Request for Bids
Autoclave- BIA
Bid No.: B16-012 REBID
Issue Date: September 8, 2015

Addendum No. 1

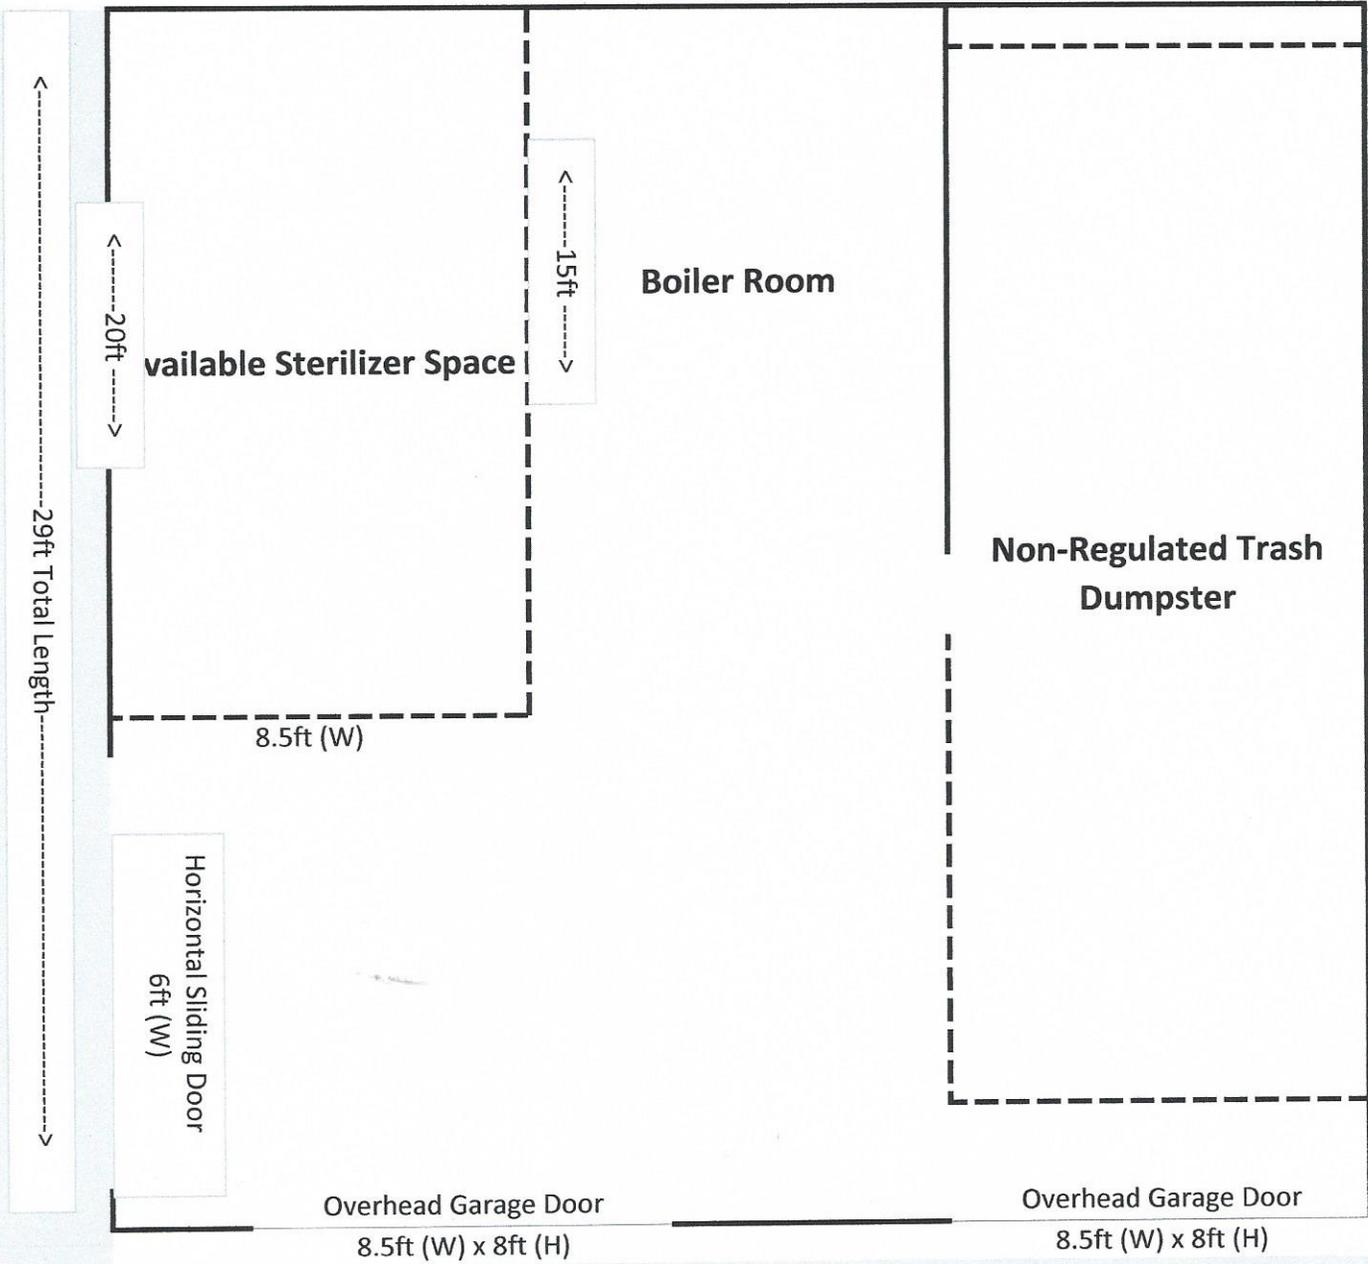
5. Q: Can you provide a floor plan room drawing or dimensioned sketch? Photos would also be helpful. This would allow potential bidders to review the site and ensure there are no space constraints.

A: Please see attached floor plan.

*All measurements approximate

*Maximum height available 8.6"
